Contract #: 04-0120F4Cty: SF/ALA Rte: 80 PM: 13.2/13.9File #: 69.25B**QUALITY ASSURANCE -- NON-CONFORMANCE REPORT****Location:** Changxing Island, Shanghai, P.R. China**Report No:** NCR-000455**Prime Contractor:** American Bridge/Fluor Enterprises, a JV**Date:** 29-Sep-2009**Submitting Contractor:** Zhenhua Port Machinery Company, Ltd (ZPMC), Changxing Island**NCR #:** ZPMC-0428**Type of problem:**

Reference Description: Missed MT longitudinal and transverse indications by QC for Segment 6CE deck drainage plate and X3S Stiffeners

Job Name: SAS Superstructure
Document No: 05.03.06-000418

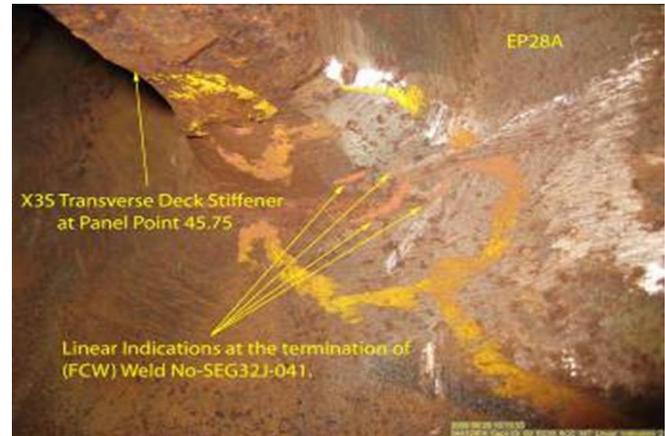
-Deck Drainage Plate to Deck Plate Attachment Fillet Weld-OBE6D-005: Three (3) 10mm Transverse Indications.

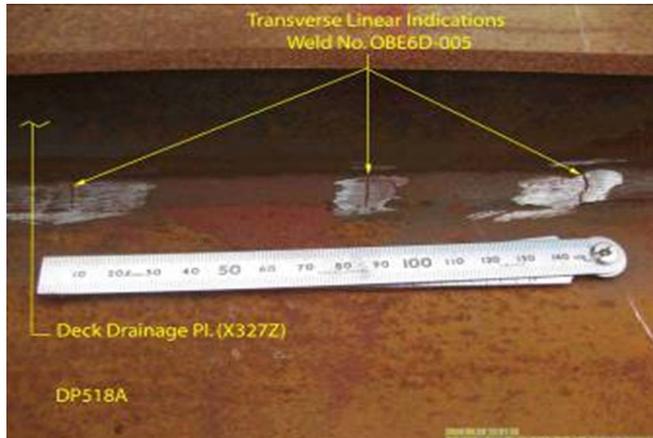
-X3S Stiffener to Edge Plate CJP Weld at PP45.75 Weld -SEG32J-041: Four (4) 5-20mm Longitudinal Indications.

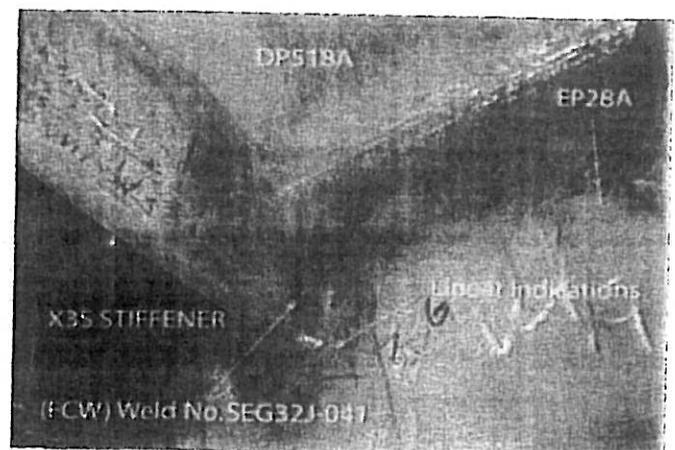
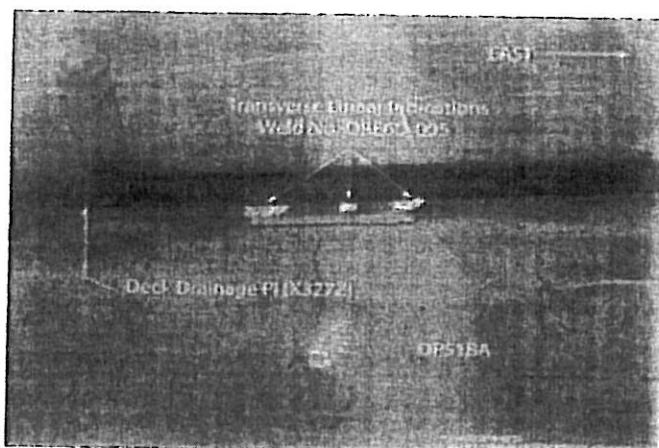
During a random verification of Magnetic Particle Testing (MT) of the various components in OBG segment 6CE, a Caltrans Quality Assurance (QA) Inspector discovered a total of three (3) transverse and four (4) longitudinal linear indications that measured from 5mm to 20mm in length.

-Deck Drainage Plate to Deck Plate Attachment Fillet Weld-OBE6D-005: Three (3) 10mm Transverse Indications.

-X3S Stiffener to Edge Plate CJP Weld at PP45.75 Weld -SEG32J-041: Four (4) 5-20mm Longitudinal Indications.
